November 30, 2021

**Re: Comments on I-495 & I-270 Managed Lane Study Supplemental Draft Environmental Impact Statement and Updated Draft Section 4(f) Evaluation**

Figure 1: Northbound Inner Loop Throughput 5-6 p.m. – 2017 from DEIS, 2045 from SDEIS

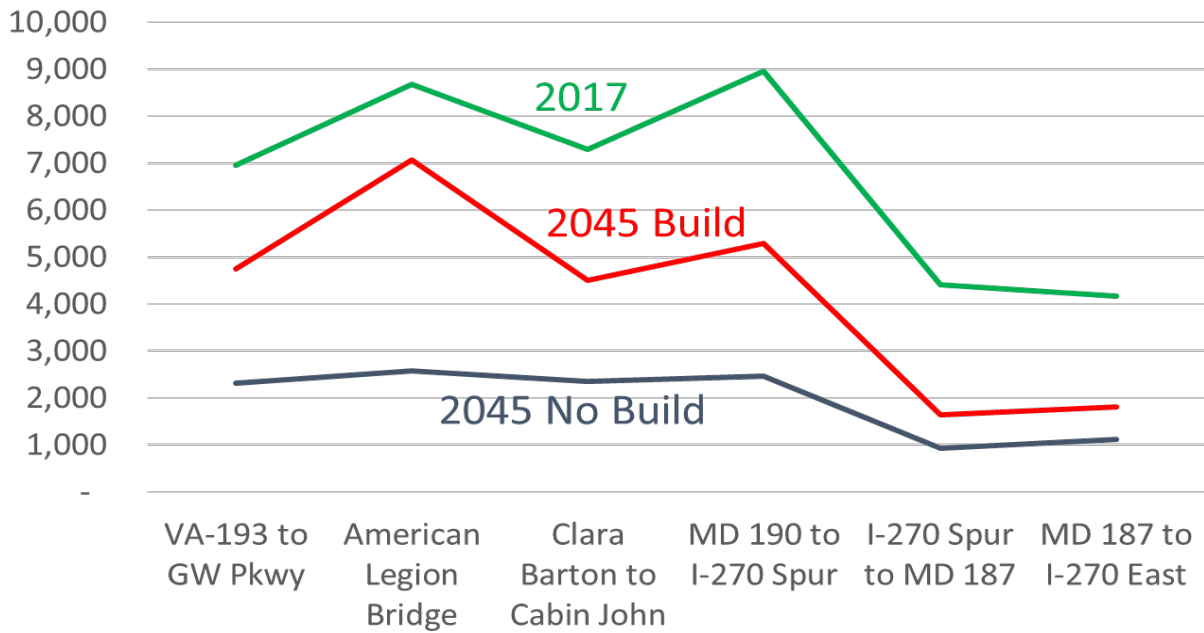
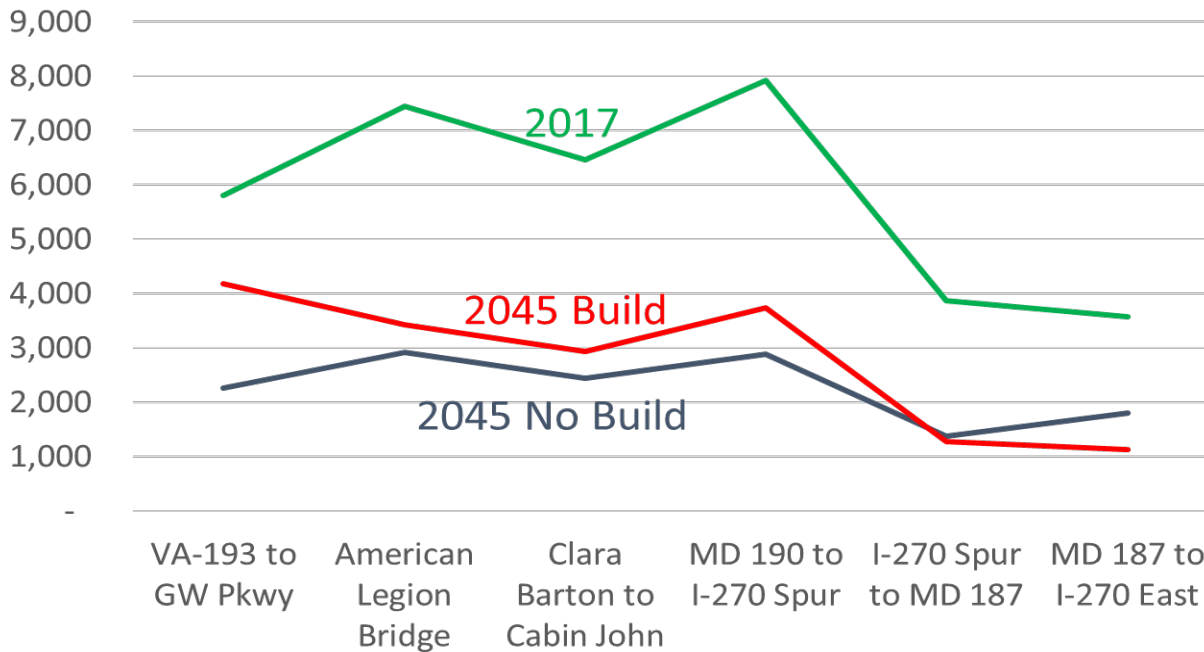
There is no real-world rationale for future throughput being significantly lower than today. Without widening, throughput will be very similar to today because the road is already congested. With widening, throughput also will be very similar to today because traffic flow will be metered by the downstream bottlenecks. The SDEIS compares two sets of wrong 2045 throughput numbers and presents the difference between them as a performance metric. This is invalid.

In the DEIS, the Inner Loop afternoon peak hour volume (5-6 p.m.) on the American Legion Bridge is reported to be 8,760 vehicles per hour. This segment has 5 travel lanes today, so the average volume is 1752 vehicles per lane per hour. In the SDEIS future Build model, 2 managed lanes are added so there would be a total of 7 lanes. The SDEIS reports the throughput as only 3,430 vehicles in the 6-7 p.m. hour, i.e., less than 500 vehicles per lane per hour – less than the traffic volumes on city streets interrupted by traffic signals. This is obviously wrong.

*Figure 3: Preferred Alternative 2045 Inner Loop American Legion Bridge Demand, Throughput and Cumulative Unserved Demand (Queue) in the Afternoon Peak Period*

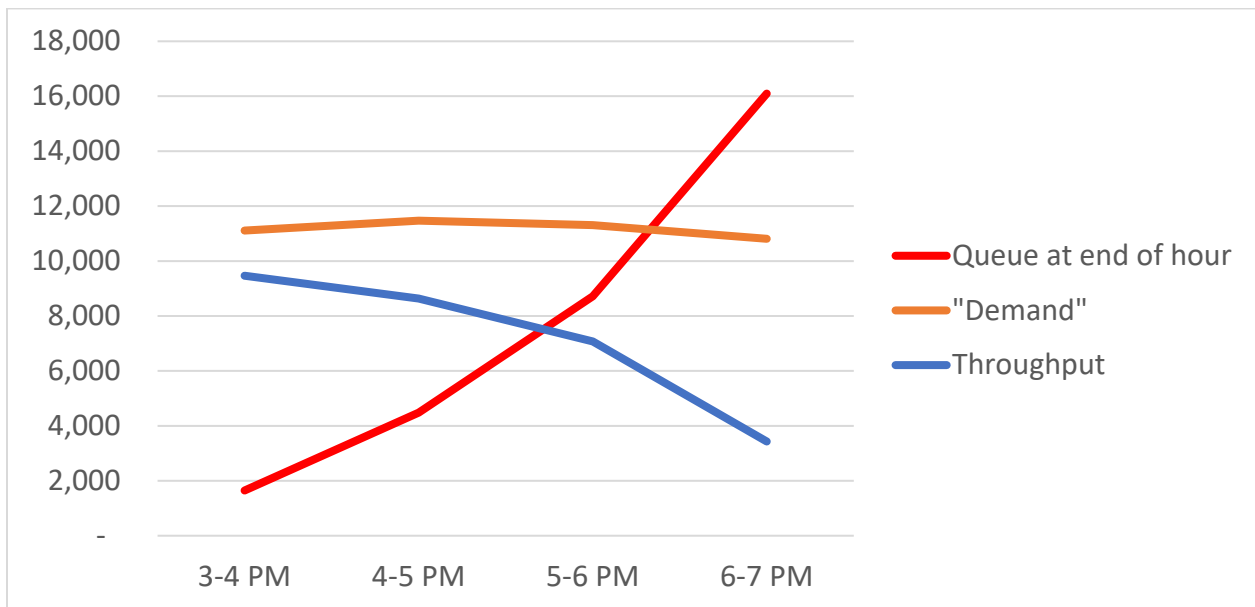
The VISSIM model is overwhelmed by the “garbage in” “demand” and translates it into unrealistically- low throughput. The SDEIS calls the difference between “demand” and “throughput” “demand unserved.” During the afternoon peak period (3 -7 p.m.) in the inner loop there is unserved demand in each of the four hours, and the VISSIM model queue becomes longer and longer through 7 p.m. This queue of cumulative unserved demand is not reported in the SDEIS but is easily calculated from the demand and throughput numbers. Figure 3 shows demand, throughput, and cumulative unserved demand.

Assuming that there is no traffic backed up at the beginning of the simulation (3 p.m.), the traffic backup (queue) grows exponentially over the 4 hours of the afternoon simulation to over 16,000 vehicles at 7 p.m. Clearing this accumulated queue in VISSIM would require many hours of additional simulation

Figure 6: Impossible Traffic Forecasts in MWCOG 2040 No Build Afternoon Peak Period (Segments with Volume/Capacity Greater than 1.1 Shown in Red)<sup>54</sup>

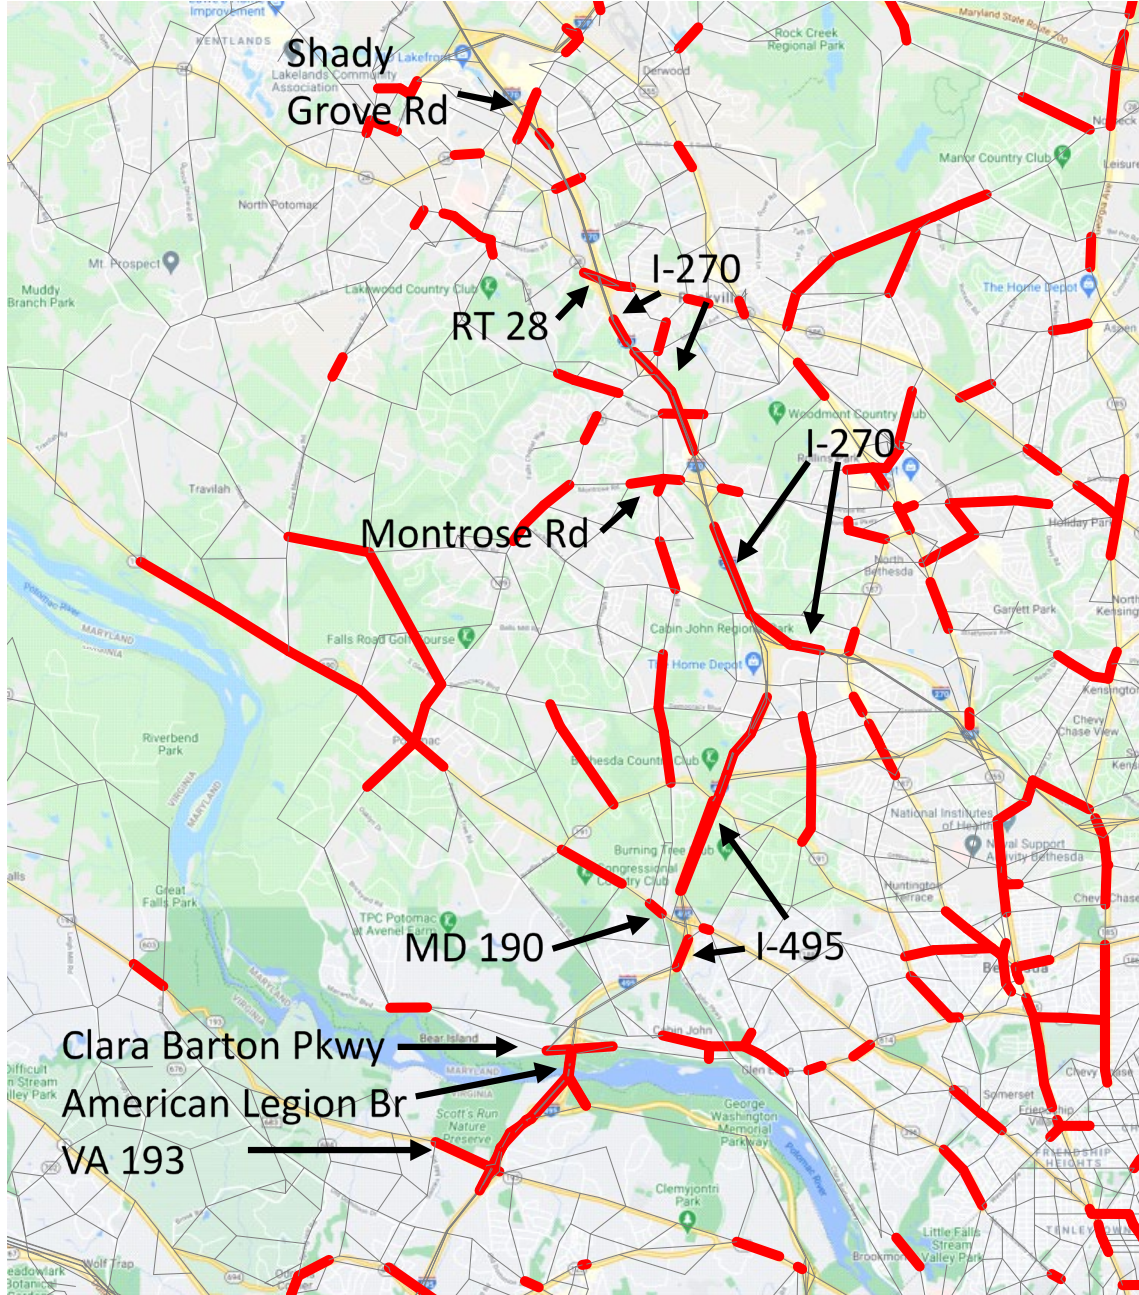
In the DEIS, many segments of I-495, I-270 and other roads are loaded with v/c greater than 1.1 (Figure 6). Horowitz admonishes that the DEIS modeling should not be published with v/c > 1.1. Therefore, these model results should not be used for planning purposes. The DEIS not only does publish these modeling results and uses them for planning, but even goes so far as to represent these over-capacity assignments as a performance measure. This claim is false and is rebutted in the Appendix B of this report section (Section II.F).

Figure 7: Wildly Impossible Potomac Bridge Traffic Forecasts in MWCOG 2040 No Build Morning and Afternoon Peak Periods

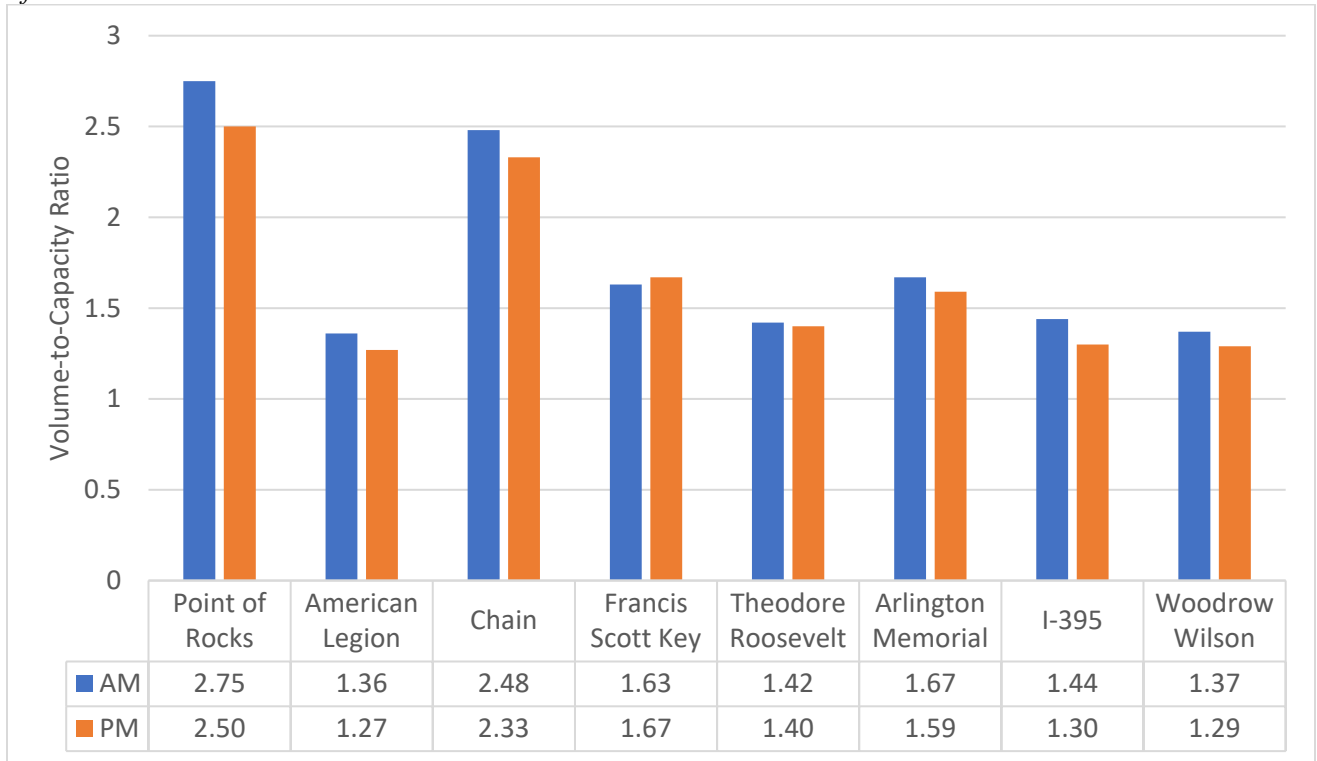
In the DEIS 2040 no build model, MWCOG morning and afternoon peak period traffic volumes for all Potomac River bridge crossings are ridiculously high (Figure 7). All greatly exceed the 1.1 volume-to-capacity ratio threshold, and range as high as 2.75, i.e., the bridge traffic volume is 275% of the highest possible volume.

*Figure 12: 2040 No Build Regional Afternoon Peak Period VHD – Road Segments with Possible  $v/c \leq 1.0$  vs. Impossible  $v/c > 1.0$*

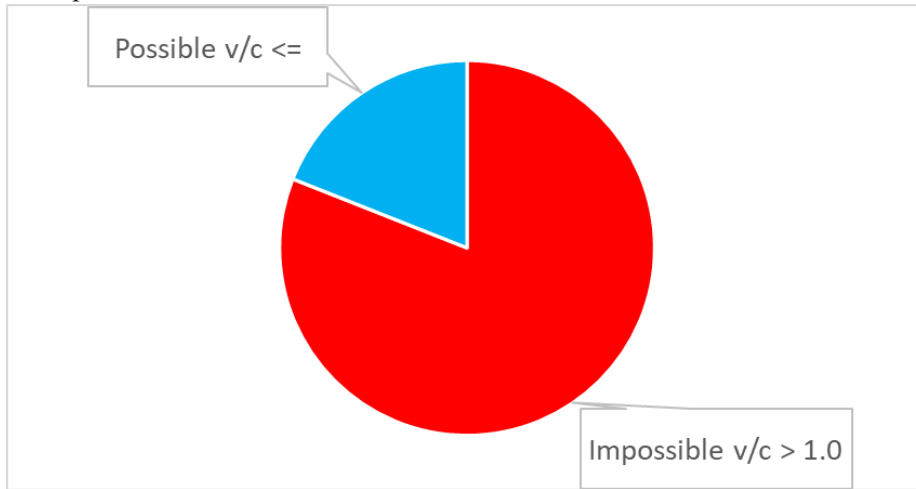
As shown in Figure 12, most (81%) of regional afternoon peak period VHD in the 2040 no build modeling is from impossible assignments with volume-to-capacity ratio exceeding 1.0. The exponential increases in modeled delay as a function of  $V/C$  makes MWCOG model VHD more of a metric of model errors than a metric of real-world performance.

Figure A1: Maryland DEIS Daily Traffic Data and Forecasts (Tables 3-1 and 3-2)

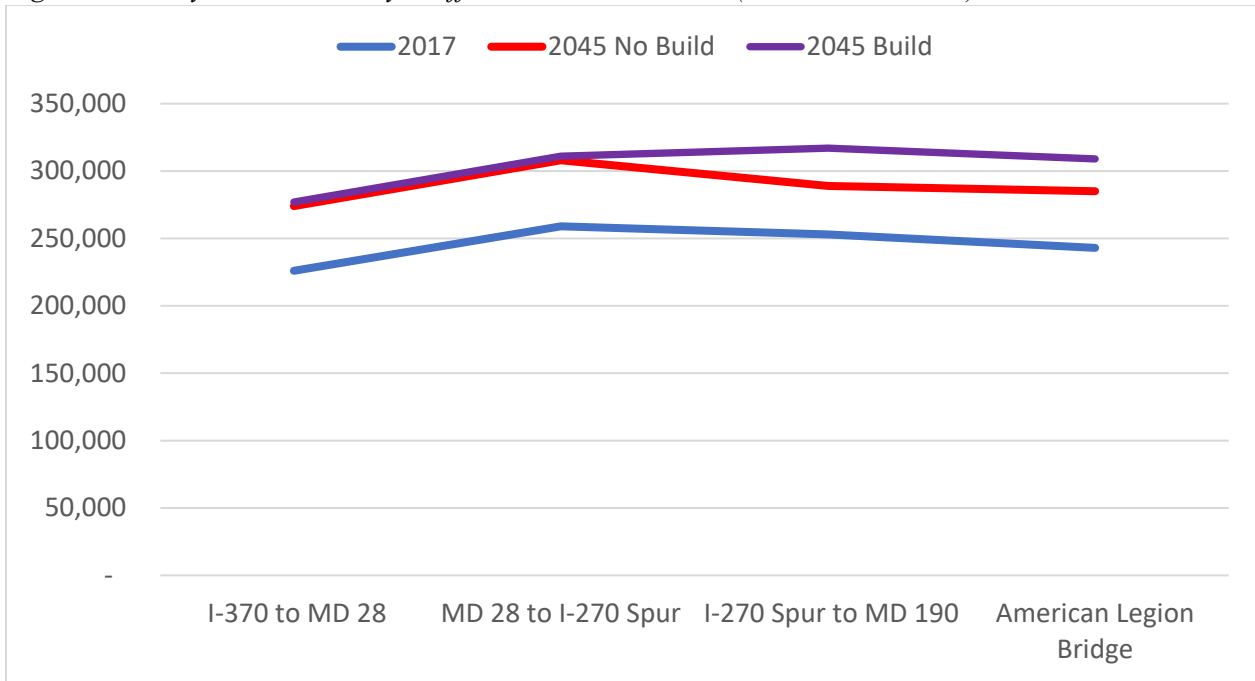
Figure A1 shows SDEIS daily traffic data and forecasts for I-495 and I-270. The SDEIS forecasts significant traffic growth in the 2045 no build alternative and only slightly higher growth for the build alternative.
